REMARKS

DRAWINGS AMENDMENTS:

ANNOTATED MARKED UP DRAWINGS

FIG. 9

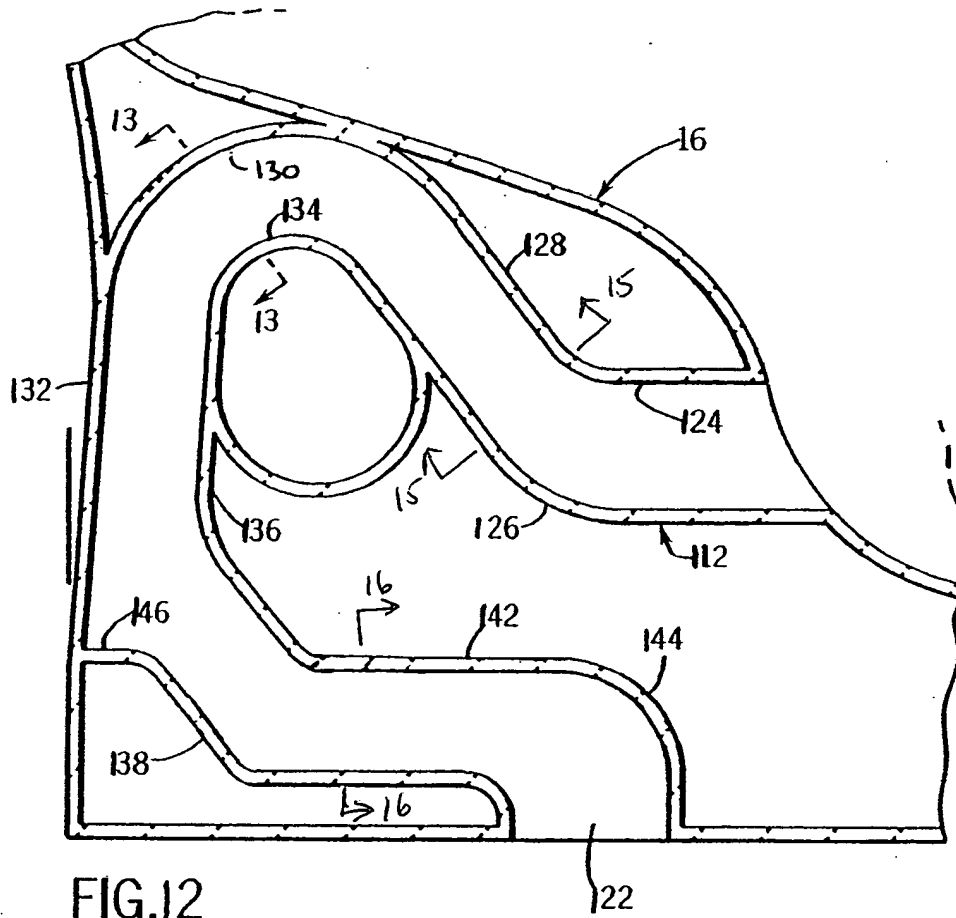
Proposed corrected FIG. 5 is also being submitted herewith to correct reference line 9-9 to match the orientation of the section shown in FIG. 9.

The enclosed marked-up drawings entitled "Annotated Marked Up Drawings" include proposed amendments to FIGS. 5 and 12 to correct reference line 9-9 and to include section reference lines corresponding to new FIGS. 15A-16B, now included in the enclosed set of formal drawings. These new figures bring the drawings into conformance with the disclosure of the specification and claims. Substitute drawings sheets entitled "Replacement Sheet" contain formal versions of FIGS. 5, 12 and 15A-16B.

Fig. 16B

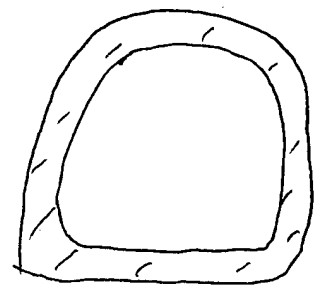
The drawings were objected to for not illustrating the subject matter of dependent claims 16 and 18. Proposed new FIGS. 15A-16B are being submitted herewith to illustrate alternate round and flat cross-sections for both the up leg and the out leg in the elected Fig. 11 embodiment. Support for these figures can be found in the written description at paragraphs 52 and 54, for example, as well as original claims 15-18 and the Table 1 at page 12. Thus, these new figures do not present new matter, but simply conform the drawings to the disclosure of the original specification.
